PLANNING, ZONING, & BUILDING DEPARTMENT
PZ&B Staff Memorandum: Architectural Commission (ARCOM)

SUBJECT: ARC-23-032 (ZON-23-041) 176 SEMINOLE AVE

MEETING: MARCH 29, 2023

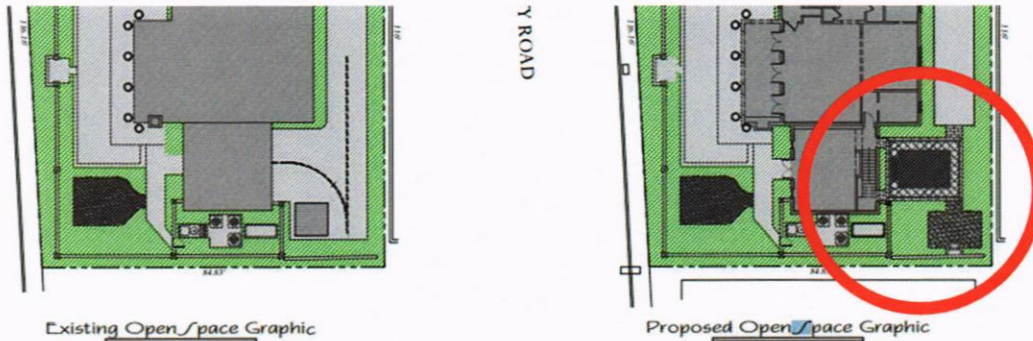
The proposal is for a construction of a 478 SF second story addition above an existing one-story garage requiring a variance from setback requirements and to exceed Cubic Content Ratio (CCR). Variance #1 seeks to establish to permit the reduction by 1'-0" of the required side (south) setback for the addition of the second floor. The existing setback is 14'-0" and for ease of construction that applicant is proposing to build coterminous to the one-story portion. One story structures setback have a requirement of 12'-6" that is increased to 15'-0" for two story portions.

Staff is supportive of the request as the setback relief impacts only the southern property which is commercially zoned.

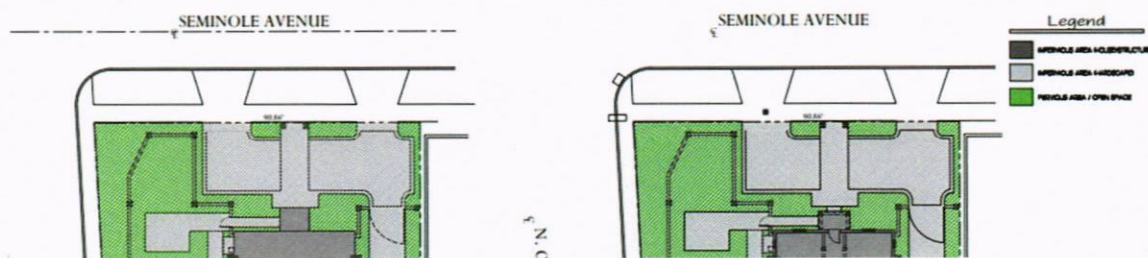
As it pertains to Variance #2, to forgo 2 required off-street parking spaces in an enclosed garage to convert it to storage space and vertical circulation, staff is supportive of the request. The garage is located in the southeastern portion of the site and accessed from Seminole Avenue in a long driveway approach.

The front motorcourt is designed with a circular driveway configuration which can accommodate the required on-site “storage” of two parked vehicles and the elimination of the expansive rear paved area and backup portion of the driveway improves the overall landscape open space of the site.
